APPLICATION NO.	FILING DATE	FIRST NAMED INVENTOR	ATTORNEY DOCKET NO.	CONFIRMATION NO.
10/591,946	11/30/2006	Stephan Oberle	27634U	6433
20529 7590 12/08/2009 THE NATH LAW GROUP 112 South West Street			EXAMINER	
			YABUT, DANIEL D	
Alexandria, VA 22314			ART UNIT	PAPER NUMBER
			3656	
			MAIL DATE	DELIVERY MODE
			12/08/2009	PAPER

DETAILED ACTION

Claim Rejections - 35 USC § 103

Figure Y: View of tooth flanks of Berlinger Jr. et al.

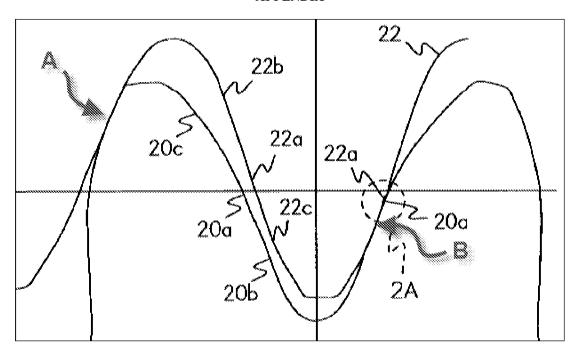
Berlinger Jr. et al. teaches the use of tooth flanks (Fig. 2) of tooth gear wheels (20, 22) comprising an involute-free mesh profile in the force transmission area (C4 / L60-65), and transition from a concave area directly to a convex area (C4 / L56-58, C5 / L7-14), effective profiles of said tooth flanks matching in a manner that the meshing of the tooth flanks occurs at planiform contact regions (C4 / L60-65; see planiform contact regions at A and B in Fig. Y below), linearly viewed in cross section, along their complete height (Fig. 2), the effective profiles of the tooth flanks coordinated with each other over their entire height (C4 / L60-65), thereby establishing said planiform contact regions (A and B; Fig. Y below), linearly viewed in cross section, along their complete height (Fig. 2) for

Effective profiles of said tooth flanks matching in a manner that it comes to planiform contact regions

(C4 / L60-65; see planiform contact regions at A and B in Fig. Y below Berlinger Jr. et al.), linearly

to >an< apparatus must be distinguished from the prior art in terms of structure rather than function. The reference discloses all the claimed structural limitations and therefore anticipates the claim. See MPEP 2114. Additionally, the teaching reference, Berlinger Jr. et al., expresses that gear assemblies that have a "variable angular velocity ratio" are "generally noisy" (C1 / L29-35) as compared to one with a constant angular velocity ratio, however, it is further expressed in Berlinger Jr. that the design of Chun as modified by Berlinger Jr. et al. may provide a constant ratio of the angular velocity (C4 / L66-67; C5 / L1-3). Therefore, one of ordinary skill in the art would recognize that the device of Chun as modified above inherently reduces gear noise by the transition from the concave area provided with profiles of said tooth flanks matching in a manner that the meshiong of the tooth flanks occurs at planiform contact regions, as described above.

In response to Applicant's argument that Chun as modified above fails to suggest or disclose a direct change from a concave to a convex curve in the transition zones with no involute area, Berlinger Jr. et al. discloses gear profiles that mesh with "no contact within the transition zones" (C4 / L56-58) and that contact between meshing teeth is made only along the convex addendum and concave dedendum portions (C4 / L58-60). Therefore, the fact that contact can only be made between corresponding concave and convex portions of the teeth would inherently result in a direct change from the concave portion to the convex portion during this transition phase since there are no intermediate contact points there-between.
